8-H-13-SC - on city of K

SUBJECT: MPC File # 8-H-13-SC, closure of Twentieth St between Terrace Ave & Andy Holt Ave
City Blocks 10541, 10581, 10582, & 10600

**Re: Right-of-Way Closure Request 8-H-13-SC
Block No. 10600 & 10581
CLT No. 108
Parcel No. 34**

File No. 8-H-13-SC **Closure of Twentieth Street** **(Electric)**
 Terrace Ave to Andy Holt Ave CLT Map#108 Parcel #34 City Block(s) 10600 & 10581

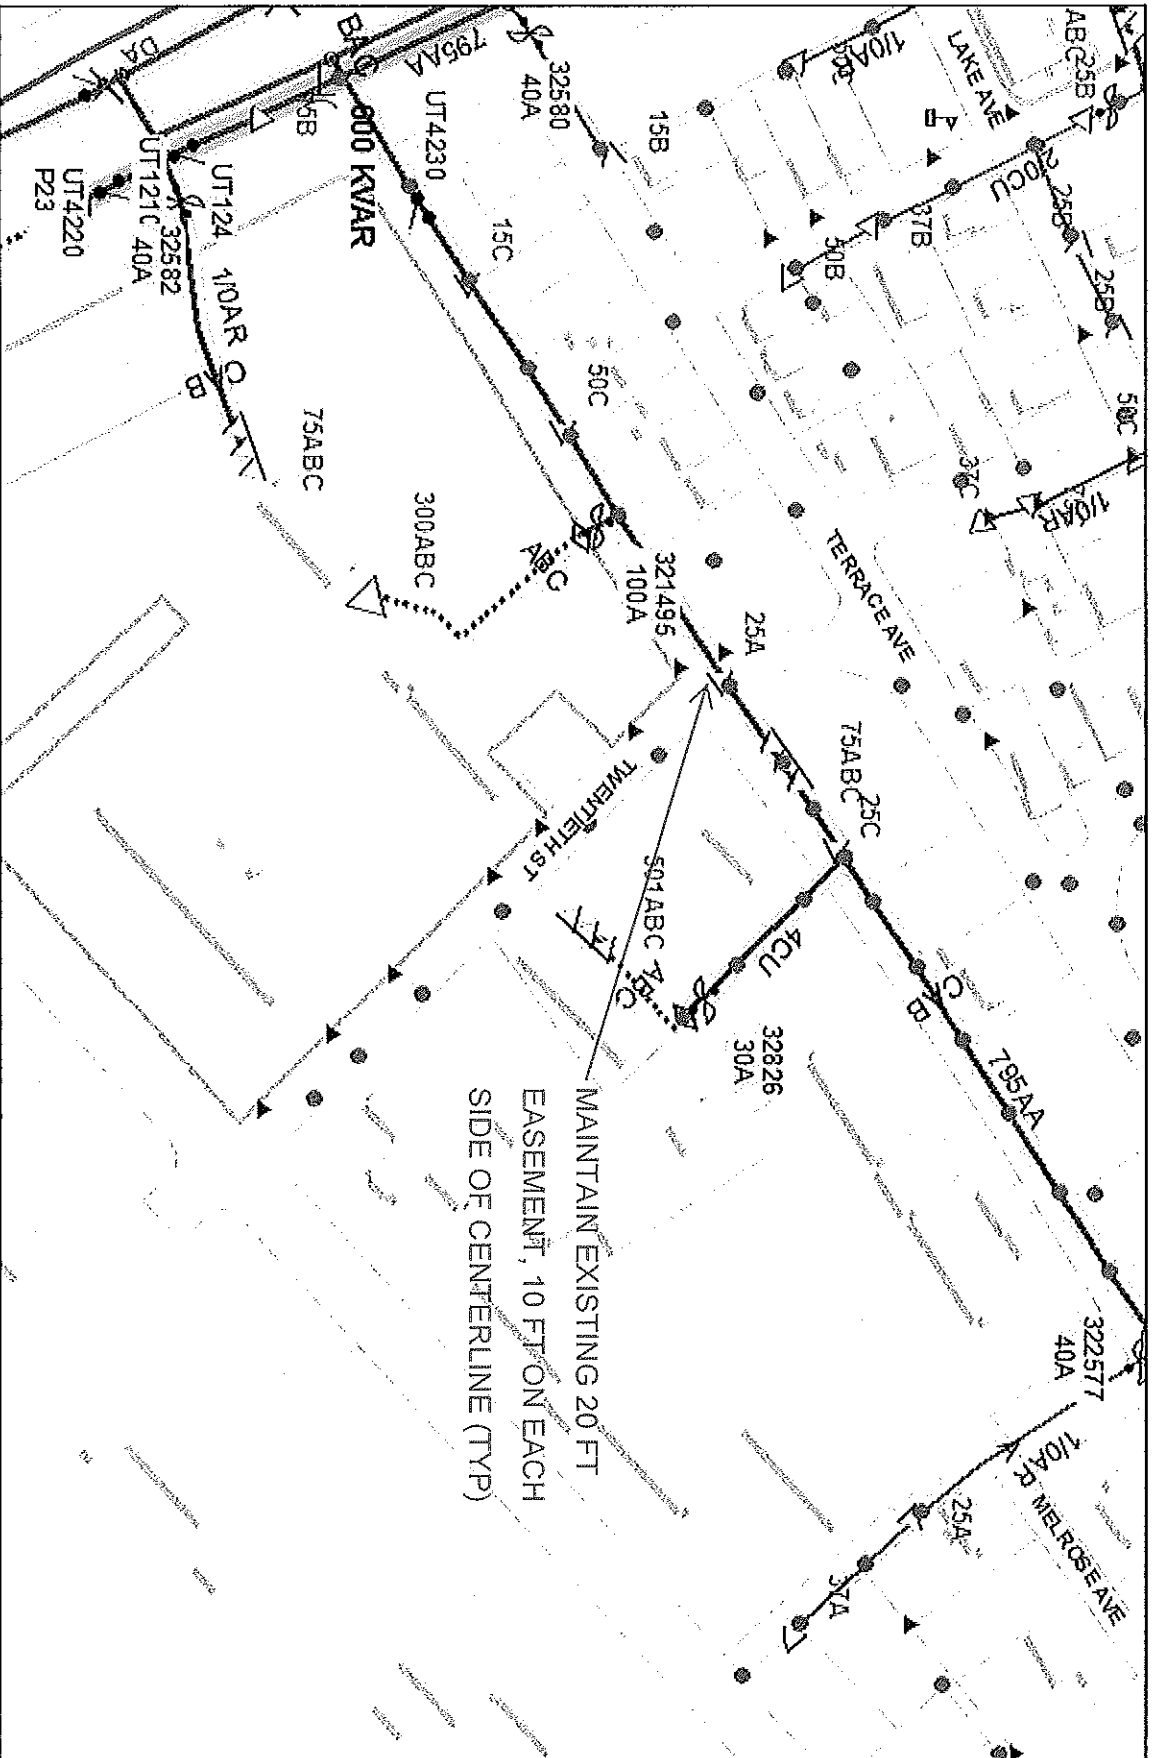
Electric – 10 feet on each side of the centerline of the electric line, 20 feet total width
Gas – 7.5 feet on each side of the centerline of the gas line, 15 feet total width
Sewer – 7.5 feet on each side of the centerline of the wastewater line, 15 feet total width
Water – 7.5 feet on each side of the centerline of the water line, 15 feet total width

File No. 8-H-13-SC Closure of Twentieth Street (Gas)

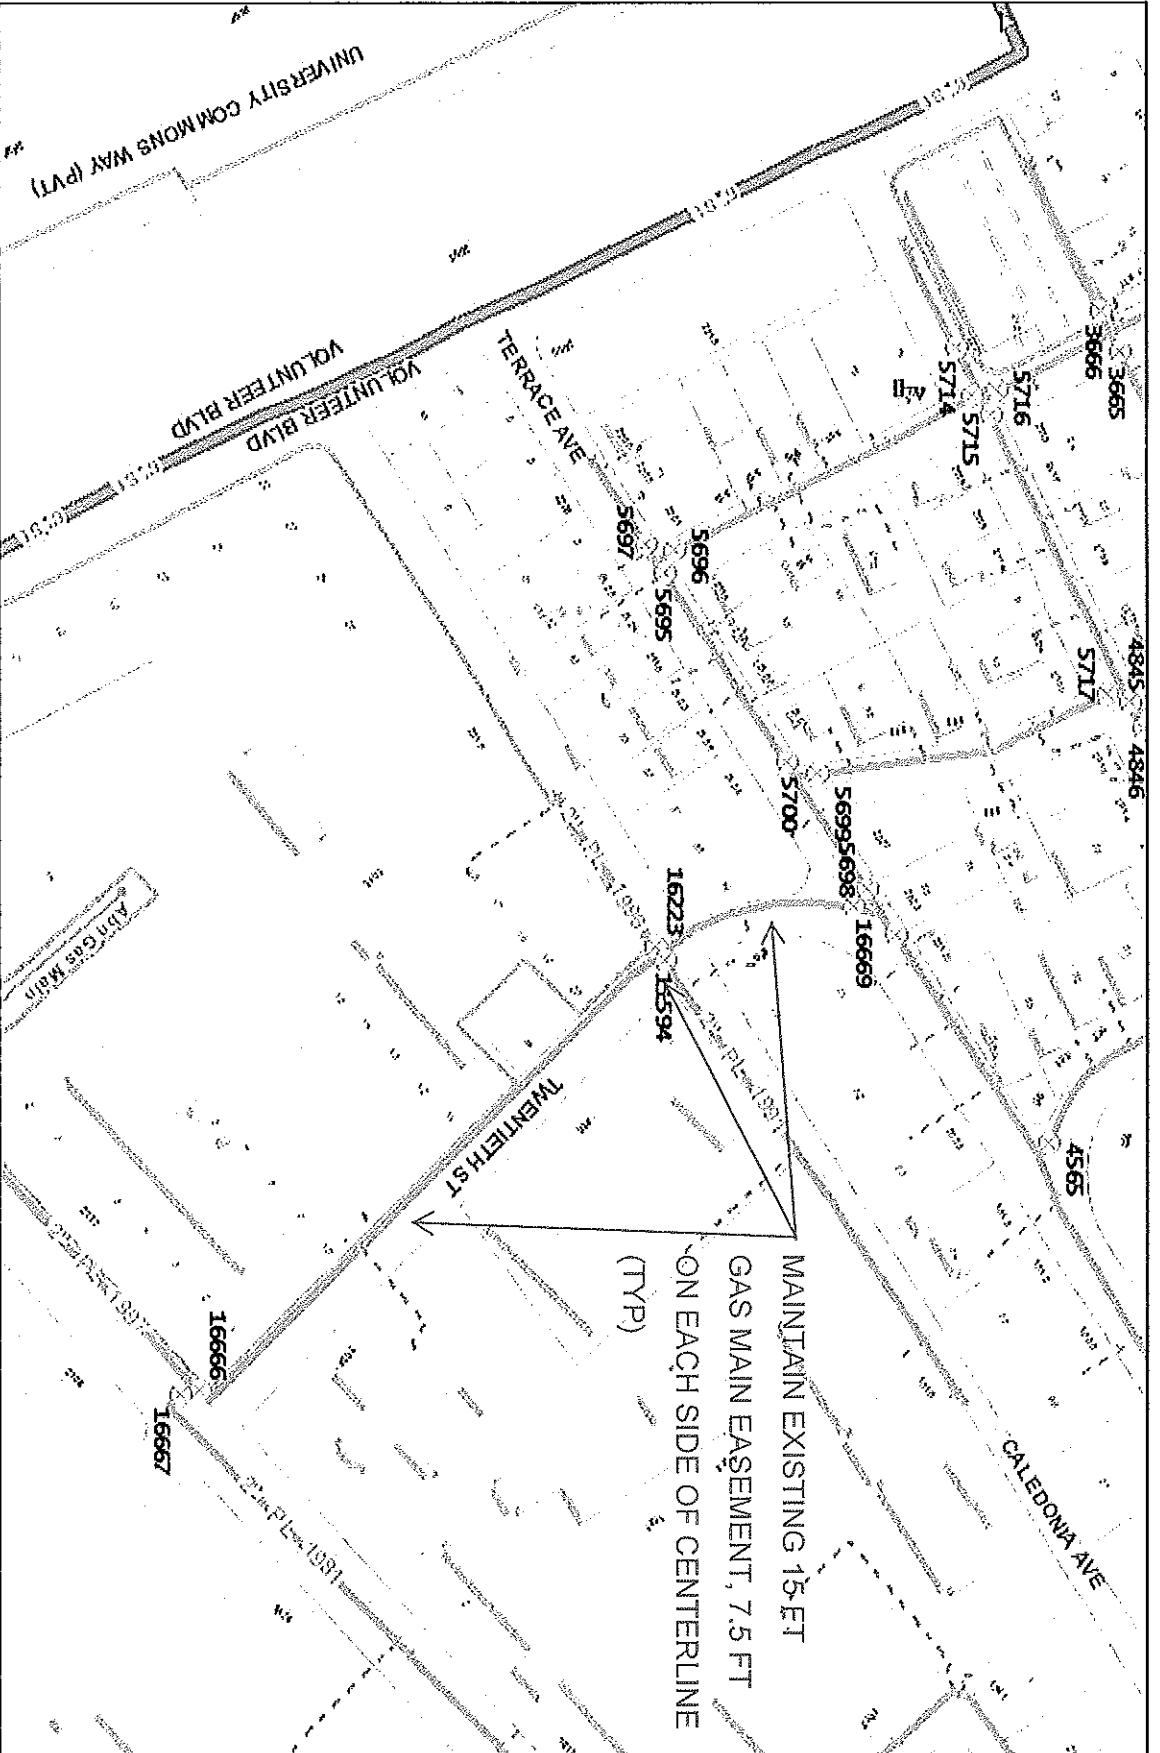
MAINTAIN EXISTING 15-FT
 GAS MAIN EASEMENT, 7.5 FT
 ON EACH SIDE OF CENTERLINE
 (TYP)
